FLORIDA DEPARTMENT OF Environmental Protection

Re: Southeast Landfill
WACS ID 41193
Hillsborough County

**Florida Department of
Environmental Protection
Inspection Checklist**

Facility Name: SOUTHEAST COUNTY SLF (PICNIC LF)

Permanent PS-2 Under Construction

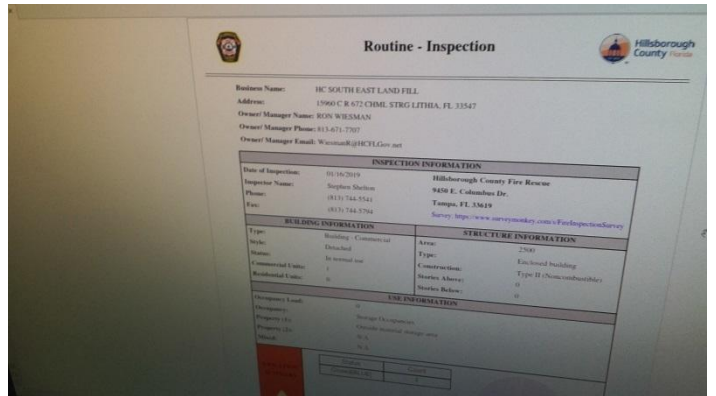
A permanent pump station, PS-2, to service the leachate cut-off trench was under construction at the time of inspection. A temporary, mobile pump station was in use instead at the time of inspection.
